Mr Declan Heery,
 432A Orwell Park Green,
 Tempelogue,
 Dublin 6,

Re:- Report on existing water main and foul sewer at 432A Orwell Park Green

Figure 1:- Section through existing boundary wall showing levels for existing water main and foul sewer

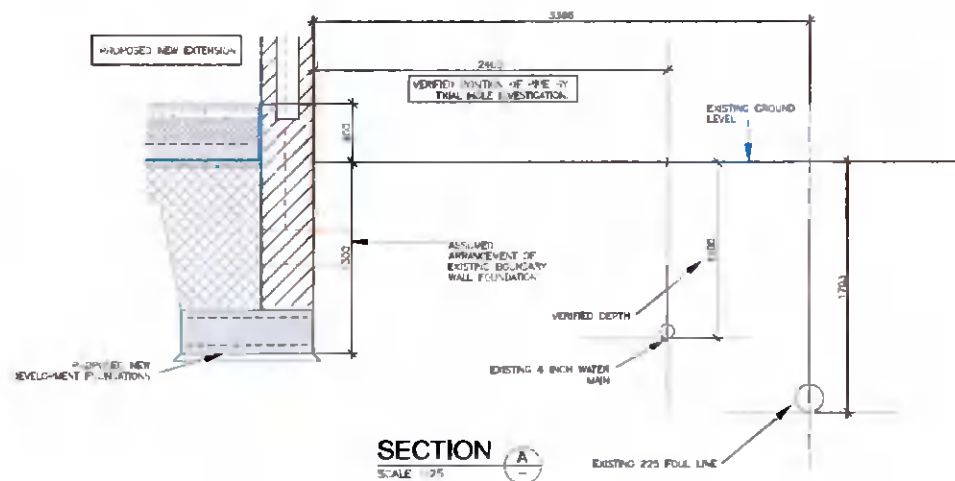
Following a review of the planning drawings and the site investigation findings for the proposed extension at the above address, I would recommend that the existing boundary wall be demolished to allow for a new foundation for the extension. The bottom of the new foundation should be 1300mm below the existing ground, so as not to induce any ground pressures on the existing water main and foul sewer as shown in Figure 1 below. The position of the existing services have been verified on site by trial hole investigation and are shown on section and the architects plan below along with an extract from the drainage record maps. See Figure 1, 2 and 3 below.
